**Economic Commission for Europe****Inland Transport Committee****World Forum for Harmonization of Vehicle Regulations****Working Party on General Safety****117th session**

**Awareness of the proximity of Vulnerable Road Users****UN Regulation on Blind Spot Information Systems (BSIS)****Proposal for amendments to UN Regulation No. [151] (Blind Spot Information Systems for Heavy Vehicles)****Submitted by the Informal Working Group VRU-Proxi\***

Appendix 1, Figure 1, amend to read:

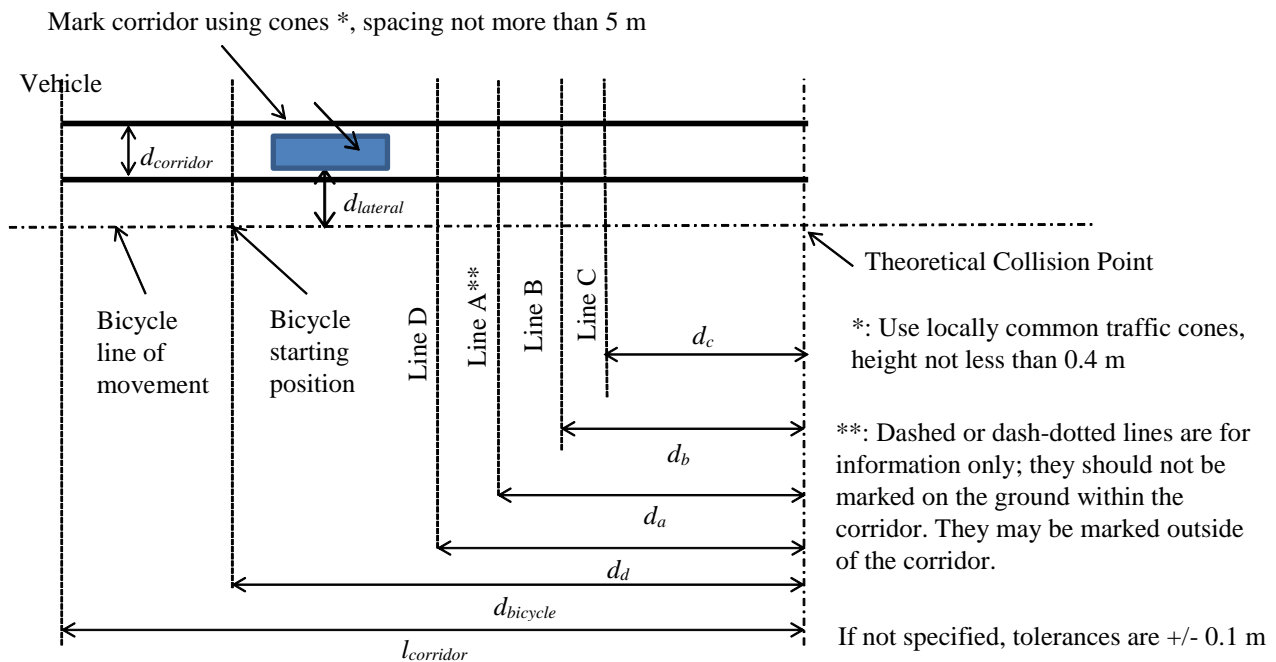
**The criterium “first point of information” is deemed to be complied with when test cases other than those from table 1 in appendix 1 to this regulation are carried out.”**

- 6.5.10. The test is passed when the Blind Spot Information signal has been activated in all test cases as shown in Table 1 of Appendix 1 to this Regulation before the **foremost point of the vehicle has reached** ~~crossed~~ **line C but not before the foremost point of the vehicle has reached line D** (see paragraph 6.5.7. above, **where line D is only relevant for test cases taken from Table 1 of Appendix 1**) and the Blind Spot Information signal has not been activated in any test run when the vehicle passes the traffic sign (see paragraph 6.5.8. above). **However, the information signal is not required when the relative longitudinal distance between bicycle and front right corner of the vehicle is more than [30] m to the rear or [7] m to the front.**

For vehicle speeds up to 5 km/h, it is deemed satisfactory if the information signal is activated 1.4 seconds before the bicycle has reached the theoretical collision point as specified in Appendix 1, Figure 1. ~~For vehicle speeds between 5 and 10 km/h, the value  $d_c$  shall be 5 m.~~

For vehicle speeds above 25 km/h, where the stopping distance is higher than 15 m,  $d_c$  as specified in Appendix 1, Figure 1 shall be as specified in Appendix 1, Table 2.
